Brunson Acres

City Plan Commission — July 31, 2025 **REVISED**

CASE NUMBER/TYPE: SUSU25-00055 – Major Combination
CASE MANAGER: Myrna Aguilar, (915) 212-1584, AguilarMP@elpasotexas.gov
PROPERTY OWNER: Deering and Domenica Brunson
REPRESENTATIVE: Del Rio Engineering, Inc.
LOCATION: North of Montana Ave. and East of Rich Beem Blvd. (Extraterritorial Jurisdiction (ETJ))
PROPERTY AREA: 4.61 acres
VESTED RIGHTS STATUS: Not Vested
PARK FEES: Park Fees Not Required
EXCEPTIONS/MODIFICATIONS: Yes, see following section
ZONING DISTRICT(S): N/A property lies within ETJ

1. To waive the construction of a 5-foot sidewalk along Square Dance Road.

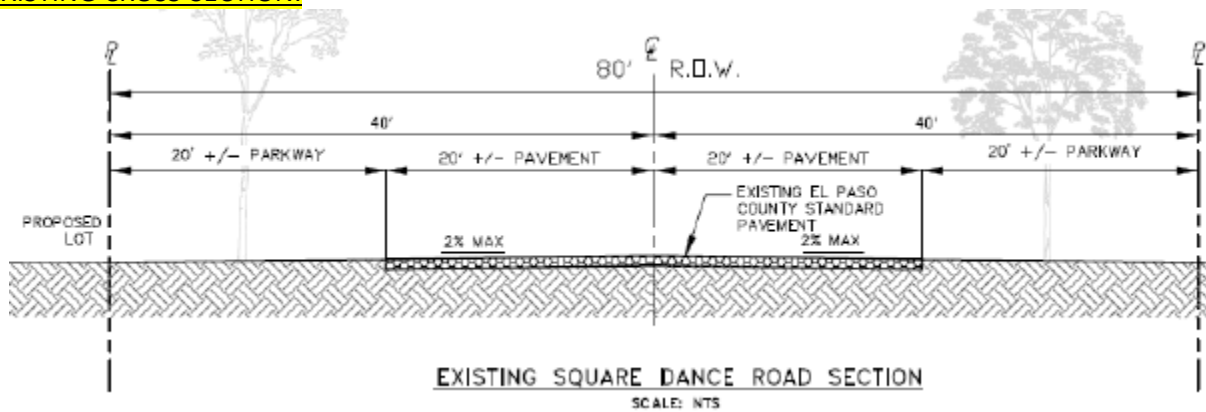
Although the request for exceptions meets the waiver criteria previously stated, staff recommends denial of the waiver of the construction of sidewalks and additional roadway based on the following:

- Corner property providing opportunity for future connectivity
- Properties in the area including immediately adjacent are not platted
- Sidewalks will provide connectivity to a Linear Park currently under construction on Square Dance Rd.

Figure B: Developed properties within a quarter mile of proposed subdivision

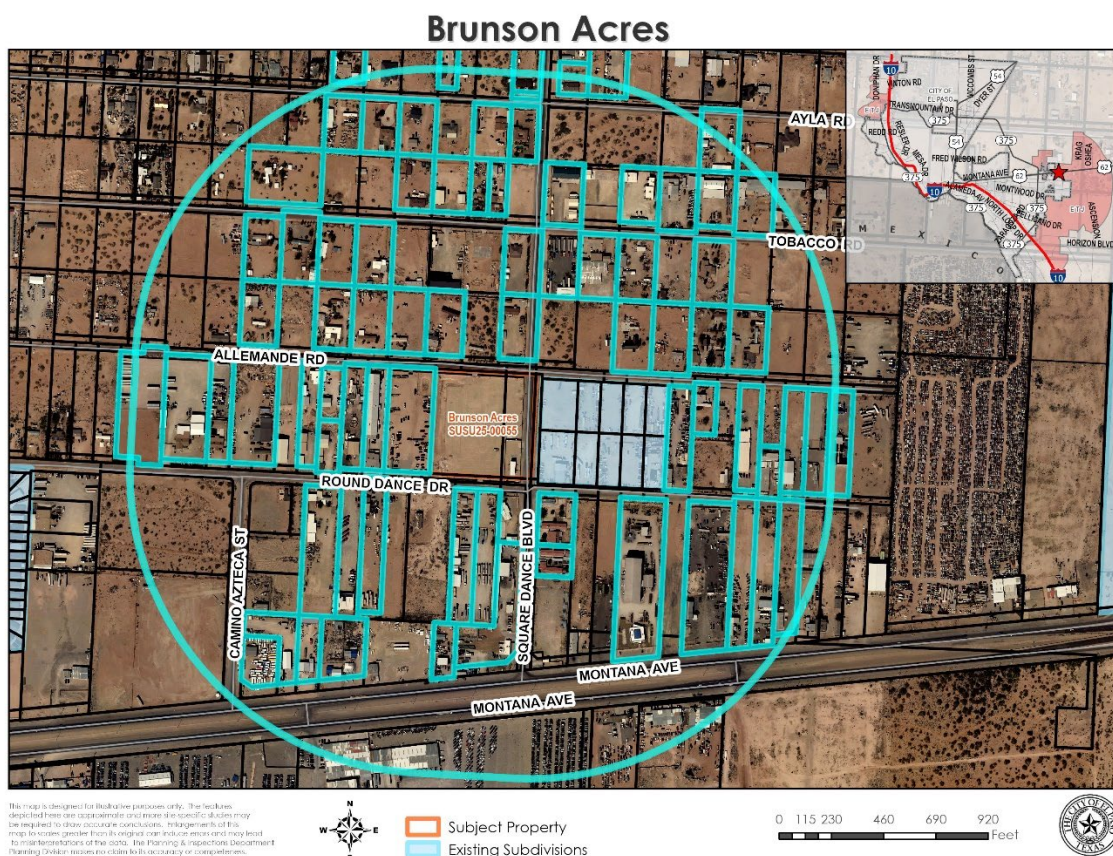
The exception request to waive the required improvements for Square Dance Road, Round Dance Road and Allemande Road meet the criteria of already developed and the existing street improvements that are in character with the neighborhood.
